To: Planning Commission  
From: Christina Robertson-Gardiner, Senior Planner  
RE: LEG 19-0003-Beavercreek Road Concept Plan Zoning and Code Amendments  
Date: September 16, 2019

Figure 1 - Goal 5 Site Inventory- Beavercreek Road Concept Plan Design Process

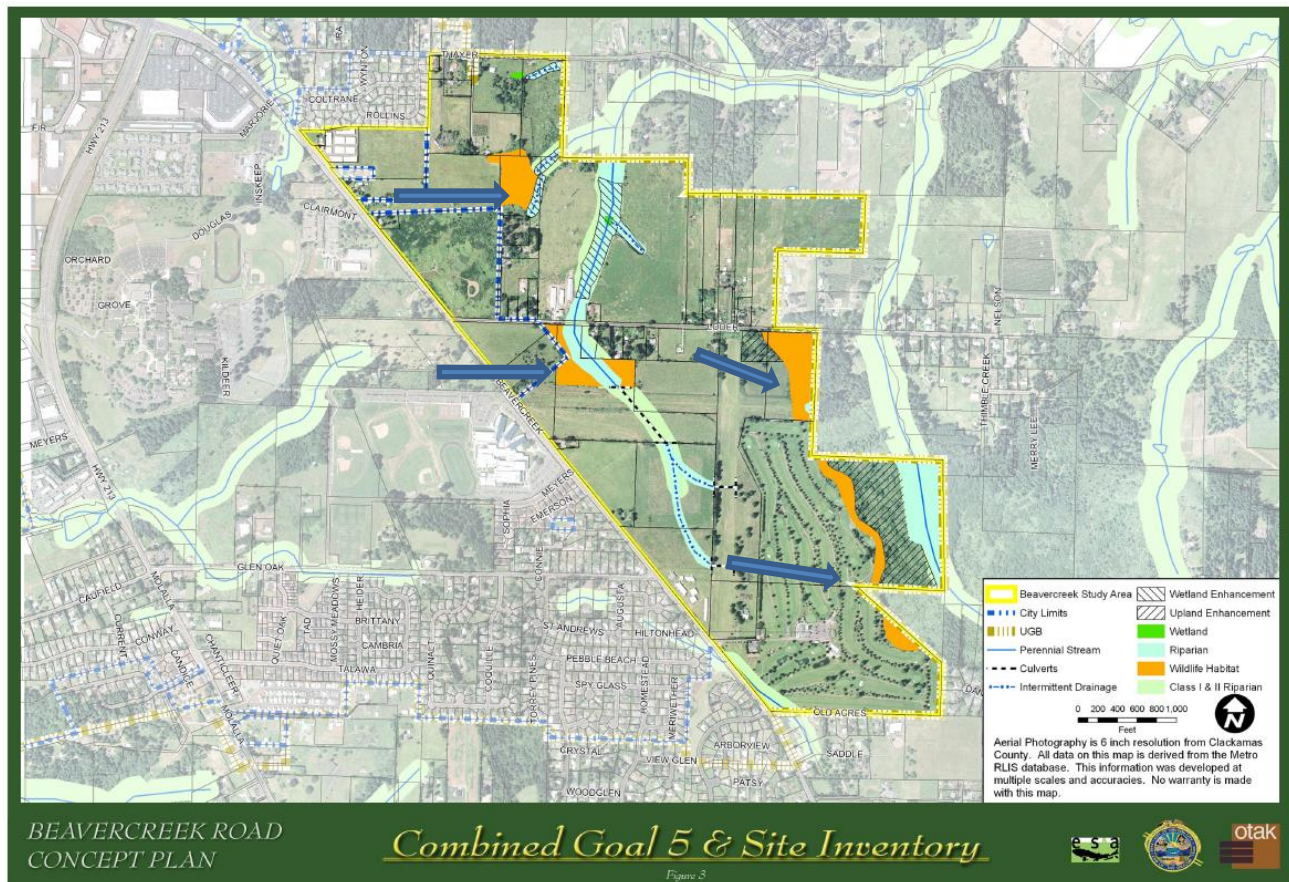
Below are three maps that further described this issue. The 1<sup>st</sup> map- Figure 1, looked at streams, wetlands and habitat areas during the Concept Plan design process prior to the adoption of the revised Title 13 code amendments. The areas identified in orange are labeled as habitat area.

The Concept Plan identified habitat area proposed to be zoned Campus Industrial (areas 1 and 2) that abuts the existing vegetative corridor which runs north along the airfield and crosses over Loder Road is not fully regulated by these two overlay districts.

The analysis contained above reviews at how the city regulates the area identified in the Beavercreek Road Concept Plan habitat areas. Staff finds that the combination of OCMC 17.49 Natural Resource Overlay District, Geologic Hazards Overlay District and Chapter 17.41 Tree Protection, Preservation, Removal, and Replanting Standards provide substantial implementation of protection standards to meet the goals and vision of the Concept Plan. Moreover, the areas with the largest gap in protection have been identified for future Campus Industrial jobs, which is a major goal of the Concept plan. At this time, no additional overlay protection or text amendment to the Beavercreek Road Concept Plan, which would clarify the approach to habitat areas is anticipated, though they could be added to the final documents if desired by the Planning Commission.

**Staff recommendation:** Staff does not recommend any revisions to the proposed code amendments.

**Figure 2 Natural Resource Overlay District (NROD)**

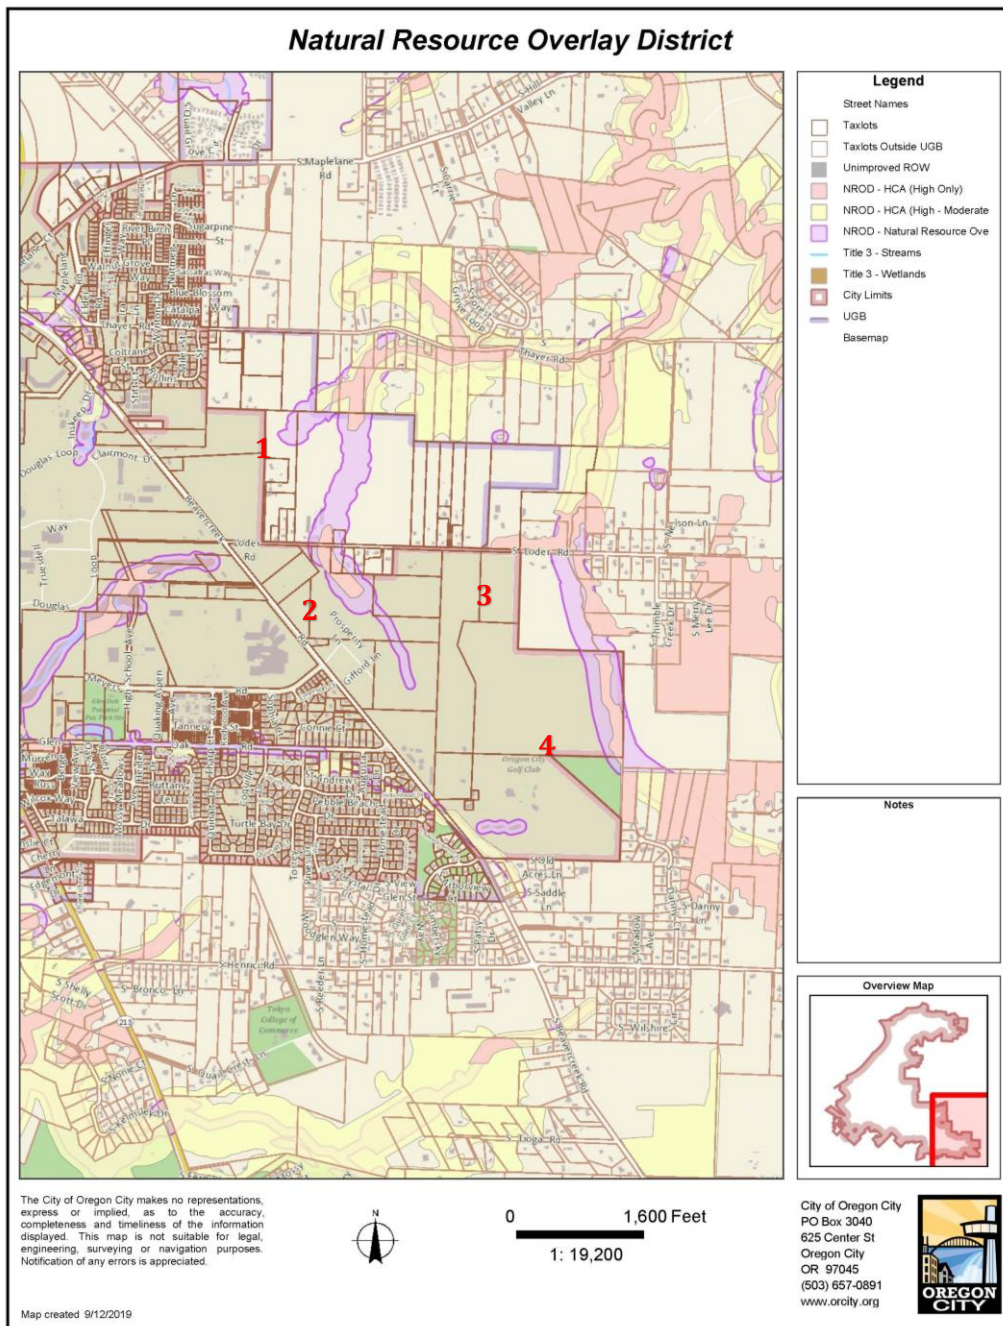
The 2nd Map- Figure 2 consists of the adopted Metro Title 13 compliant Natural Resource Overlay District. The habitat areas are identified as salmon pink, and the Natural Resource Overlay District is identified as bright pink. Please note that the Metro identified habitat areas regulated under OCMC 17.49 Natural Resource Overlay District are smaller than the habitat areas identified by the consultant team above in Figure 1 and have been demarcated with red numbers (1-4)

All of the currently regulated habitat areas located within the Natural Resource Overlay District in this area are protected through OCMC 17.49.

*Figure 3- Geologic Hazards + Natural Resource Overlay District (NROD)*

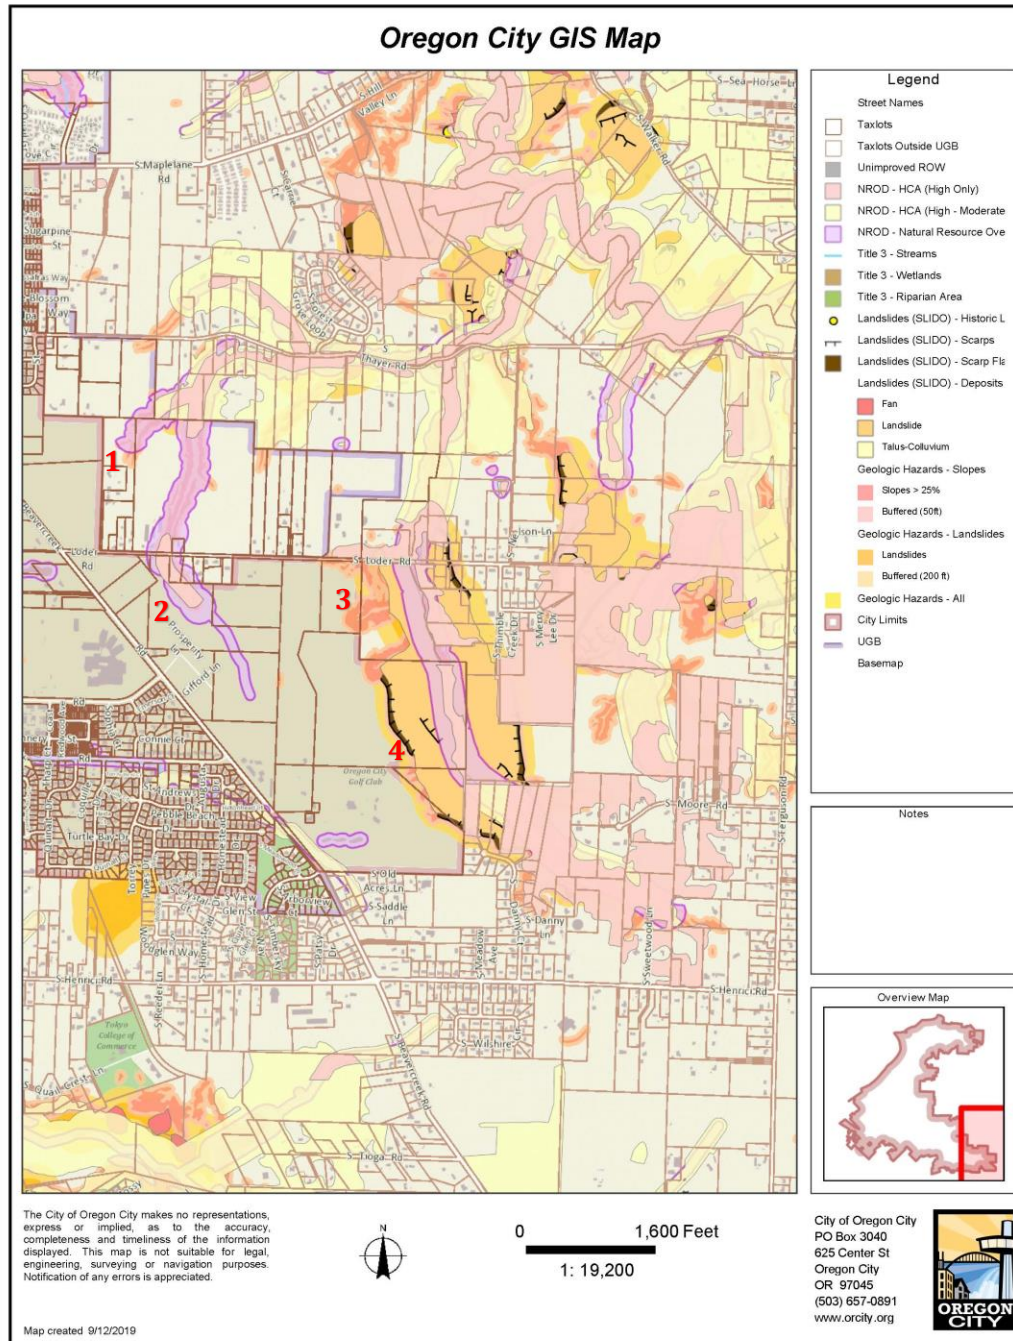
The areas located outside of the NROD District and identified as orange in Concept Plan Inventory in Figure 1 are further protected through the Geologic Hazards District. Figure 3 below identifies areas with historic landslides, sloped over 25% slope and 50 buffers around these features. Development is greatly reduced and oftentimes restricted within the Geologic Hazards Overlay District.

The Natural Resource Overlay District (OCMC 17.49) and Geologic Hazards (17.44) account for much of the concept plan identified habitat area associated with Thimble Creek Canyon (area 4) at the far SE quadrant of the plan and some of Area 3 closer to Loder Road.
